**MONTGOMERY COUNTY PLANNING DEPARTMENT**  
THE MARYLAND-NATIONAL CAPITAL PARK AND PLANNING COMMISSION

**MEMORANDUM**

**PROJECT NAME:** Bea-Kay Acres

**CASE #:** 120060500

**ATTACHMENT B**

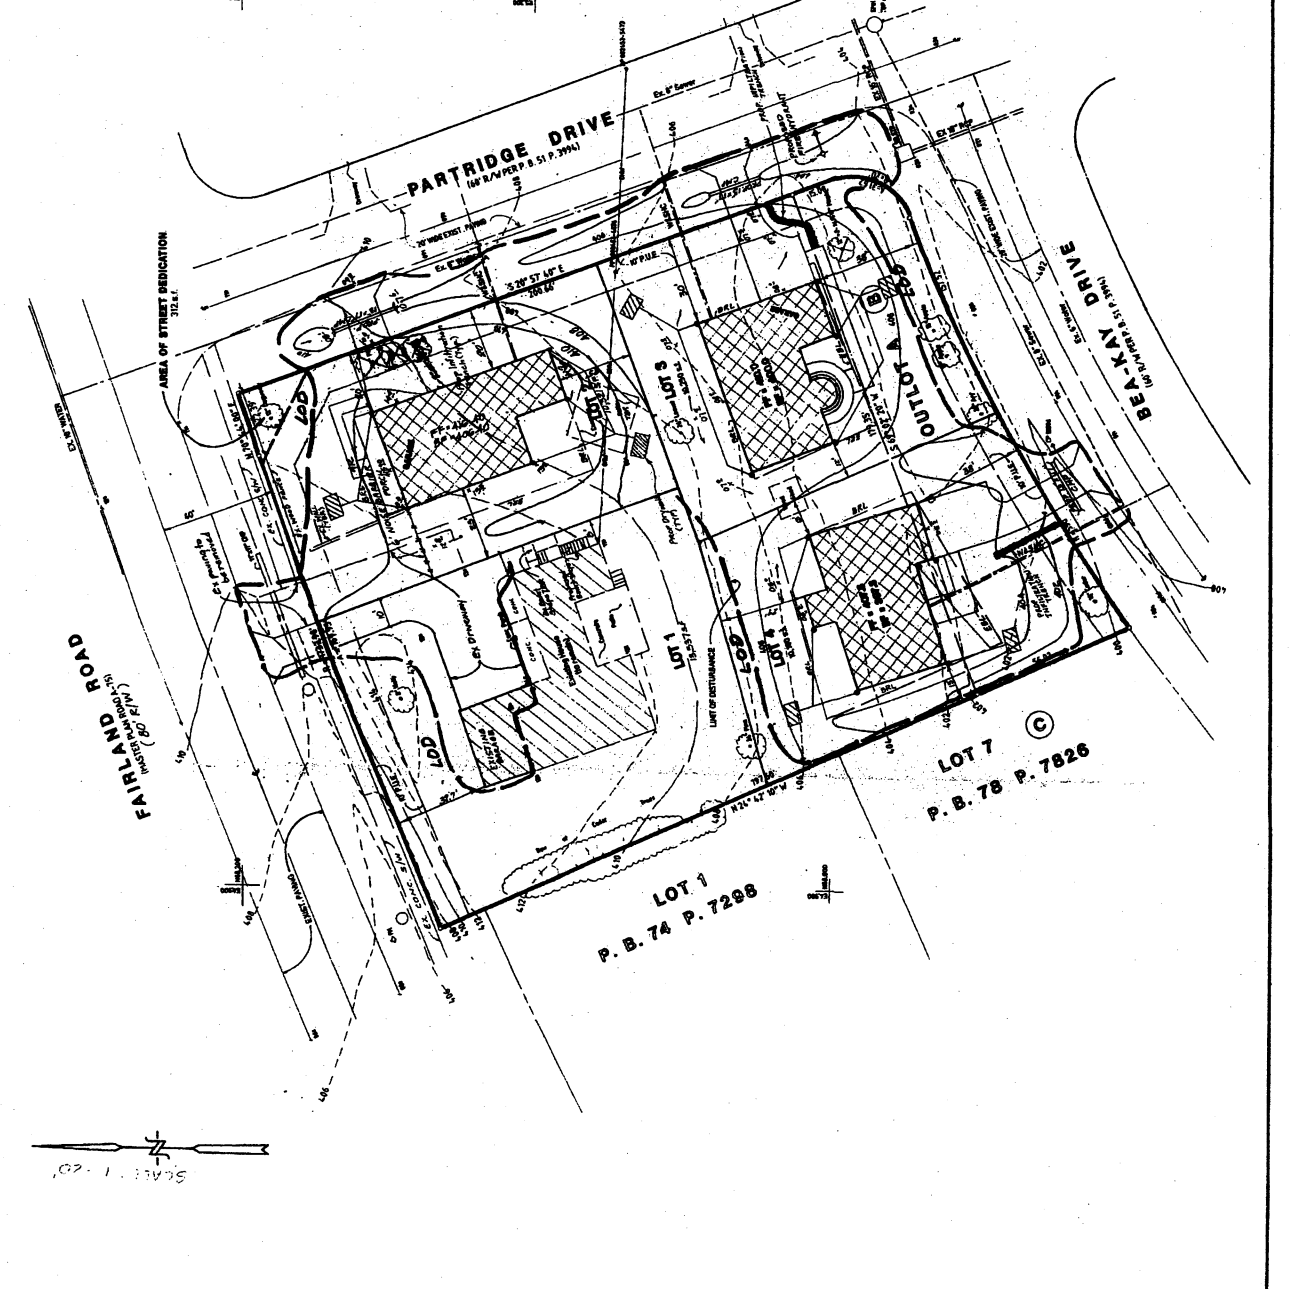
The proposed Lots 3 and 4 will be oriented with a two (2) to one (1) lot-to-lot relationship with the existing Lot 1, on the south side of Bea-Kay Drive. Although this type of orientation is not typical within the neighborhood, it does exist at the southern end of the delineated neighborhood. In Block A, Lots 13, 14 and 15 on the southeastern side of Partridge Drive, there is a three (3) to one (1) lot-to-lot relationship to Lot 3 on the northwestern side of Partridge Drive. Additionally, this is a neighborhood already in transition. Larger lots were recorded in excess of the underlying R-90 zone standards on Partridge Drive, but it seems likely that additional resubdivisions will occur over time given that most of the neighborhood is recorded pursuant to the standards of the R-90 zone. Therefore, Staff finds that the proposed orientation of the lots is appropriate for the subdivision.

**Frontage:** In a neighborhood of 32 lots, lot frontages range from 64 feet to 199 feet. The proposed lots will have frontages which range from 75 feet to 122 feet. **As such, Staff finds that the proposed lots will be consistent in character with other lots in the neighborhood with respect to frontage.**

**Area:** The existing lots in the neighborhood range in buildable area from 2,500 square feet to 11,681 square feet. The proposed lots will be 3,245 square feet, 3,540 square feet, 4,190 and 5,620 square feet in area. **The proposed resubdivision will be in character with the existing lots in the neighborhood with respect to area.**

**Lot Size:** The lot sizes in the delineated neighborhood range from 9,319 square feet to 24,109 square feet. The proposed lot sizes will range from 10,180 square feet, 10,250 square feet, 10,321 square feet and 13,537 square feet. **Therefore, Staff finds the lot sizes of the proposed lots to be of the same character as the existing lots in the neighborhood.**

**Lot Width:** The lot widths in the existing neighborhood range from 75 feet to 187 feet. The proposed lots will have minimum widths of 81 feet, 85 feet, 96 feet, and 109 feet. **As such, Staff finds that the proposed resubdivision will be of the same character as the other existing lots in the neighborhood as it pertains to lot width.**

**Shape:** There are 24 irregular lots, two (2) square lots and six (6) rectangular lots in the neighborhood. The proposed resubdivision will create one (1) rectangular lot and three (3) irregular lots. **Staff finds that the proposed lots will be of the same character as the existing lots in the neighborhood as it pertains to shape.**

**Alignment:** There are four (4) corner lots, ten (10) radial lots and 18 perpendicular lots in the neighborhood. The proposed resubdivision will create two (2) corner lots and two (2) perpendicular lots. **Staff finds that the proposed subdivision will be consistent in character with the existing lots in the neighborhood as it pertains to alignment.**

**STAFF RECOMMENDATION:** Approval, pursuant to Chapter 50-29(b)(2) of the Montgomery County Subdivision Regulations, and subject to the following conditions:

- 1) Limit the preliminary plan to four (4) one-family detached residential lots.
- 2) The builder will comply with all acoustical performance recommendations from the Henning Associates Report (“Fairland Road Traffic Noise Study”) dated September 22, 2006:

- 3) A tree planting plan for proposed Lot 1 to create a visual screen near Fairland Road for the existing house must be submitted for M-NCPPC Environmental Planning Staff review and approval prior to the pre-construction meeting for the subdivision.
